Responses to reviewers

Reviewer #1

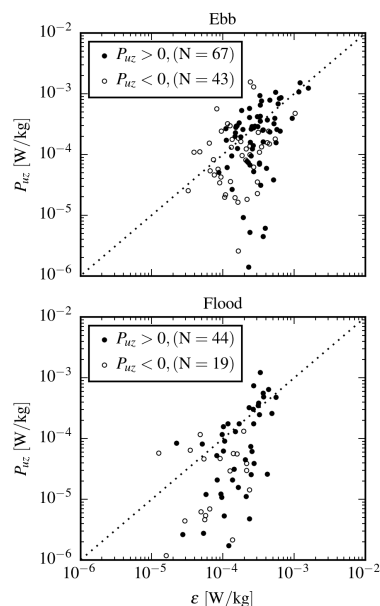
(Figure 14): There appear to be significant asymmetries between turbulent dissipation measured during flood and ebb shown in Figure 14 - can you separate the balance shown in Figure 13 and comment on flood/ebb asymmetries? How does it relate to times when production does not equal dissipation?

Thanks for this. We've expanded the discussion of ebb-flood asymmetries. However, we haven't changed Figure 13 because the prod-diss balance does not appear to be significantly different between ebb and flood. Here is a figure that makes the suggested separation:

If the reviewer thinks it is worthwhile we could switch to this figure, or we could include it as additional online material. Thanks again for asking us to look at this more. The revisions we've made are better because of this suggestion.
